Appendix 11.3

Flood Risk Assessment

Annex C: Assessment Supporting Information

CSA ID Number: 4

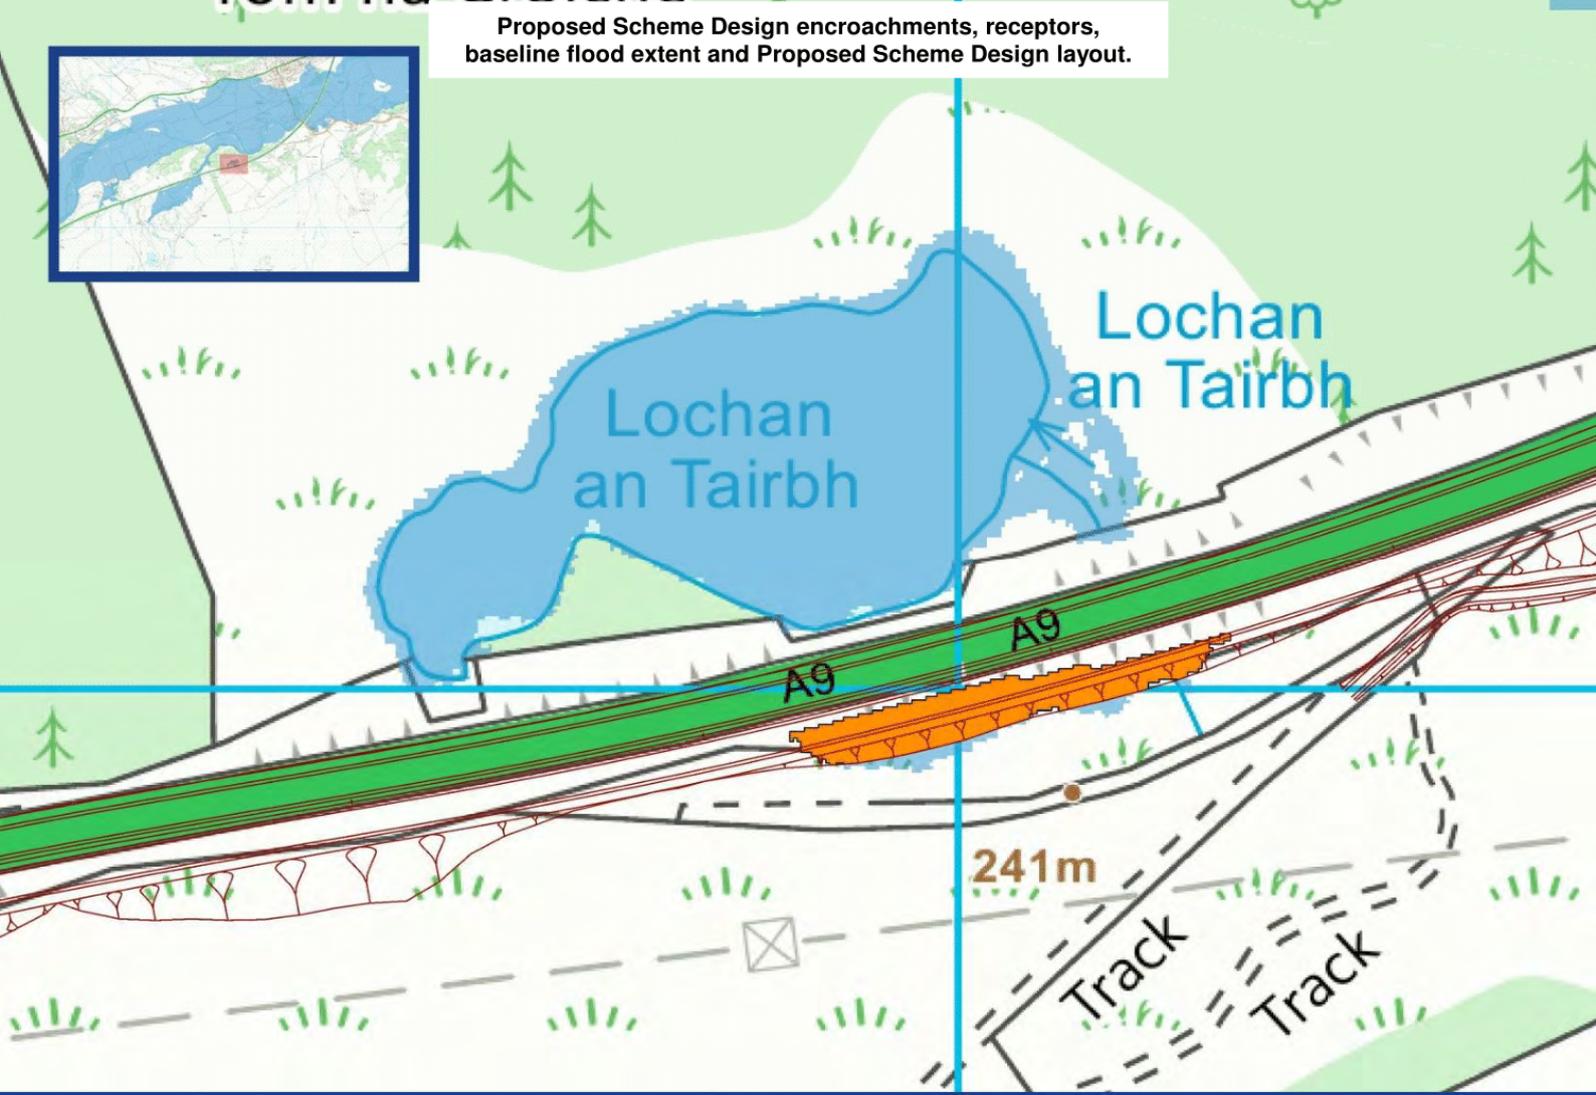
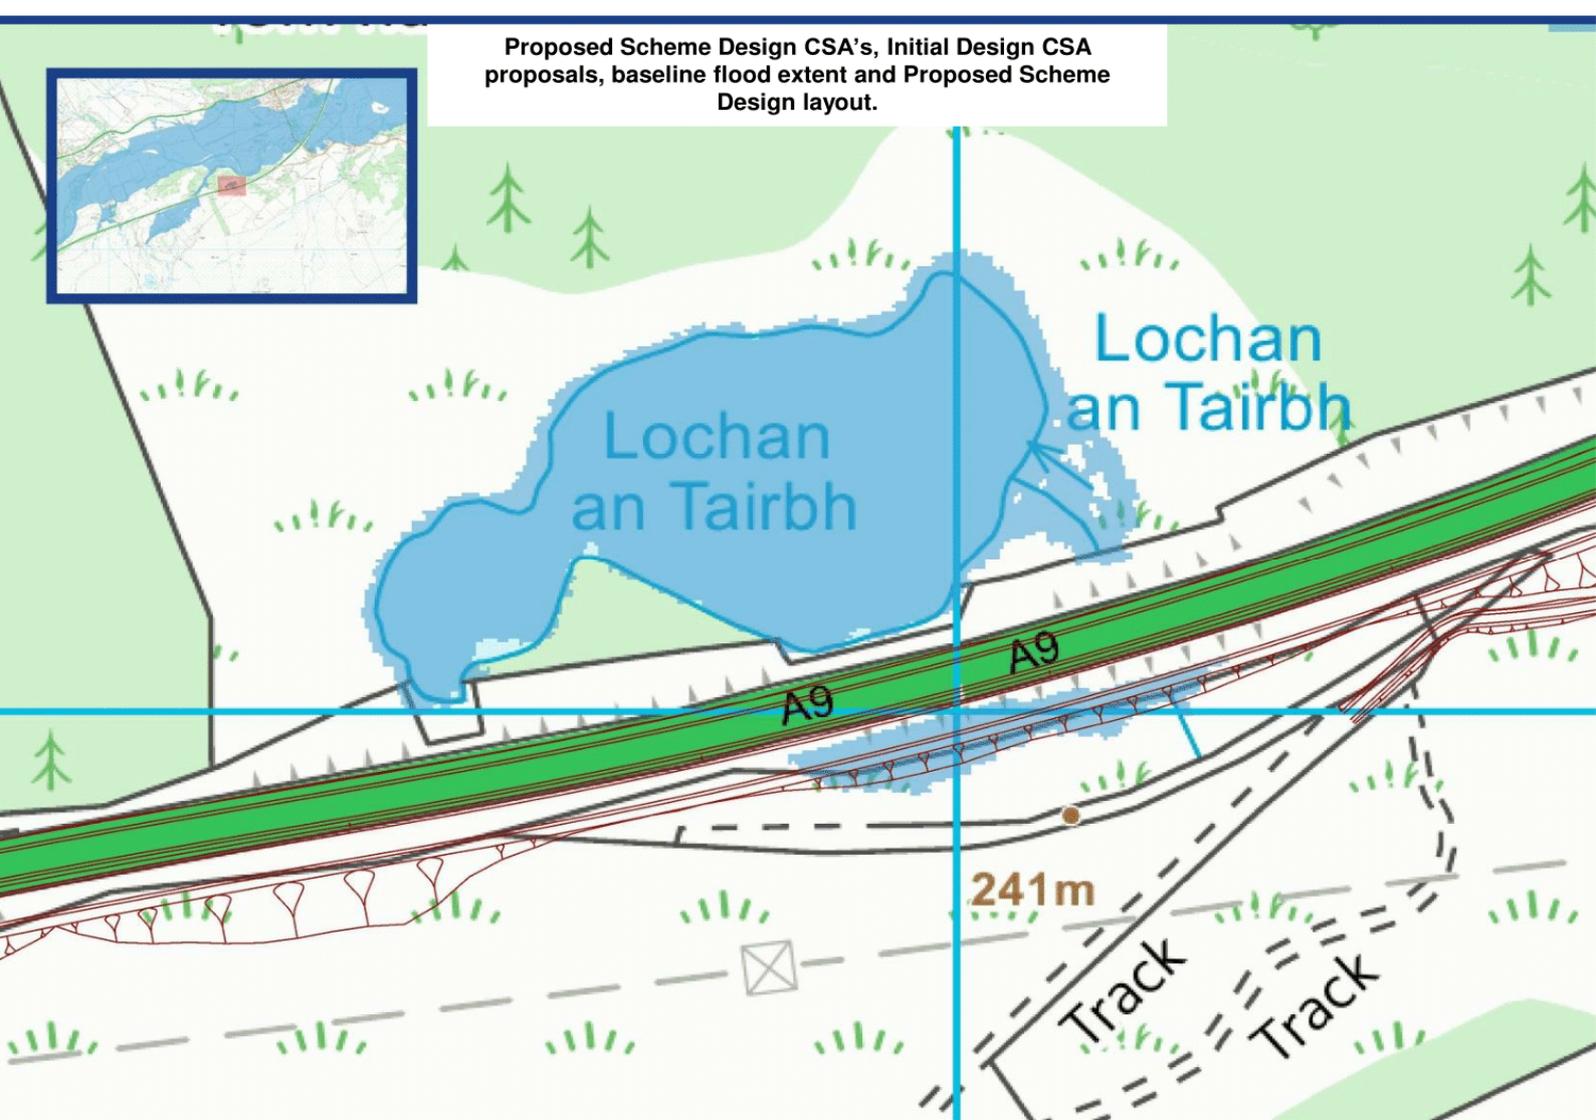
Ecology: Impacts on areas of dry heath (Annex I habitat which, whilst relatively common in Scotland, is rare across Europe). Reduce extent from areas of dry heath, or remove completely.

C&PA: Impact on track leading to Milehouse of Nuide; potential for impact upon access. Reshape to avoid track.

Road embankments have been steepened to minimise encroachment volumes.

The final option selected is for compensatory storage not to be provided as there are no downstream receptors and the increase in loch level is only slight. Water level monitoring is being carried out recording the loch level and the surrounding groundwater levels to better understand the hydrogeology of the loch.
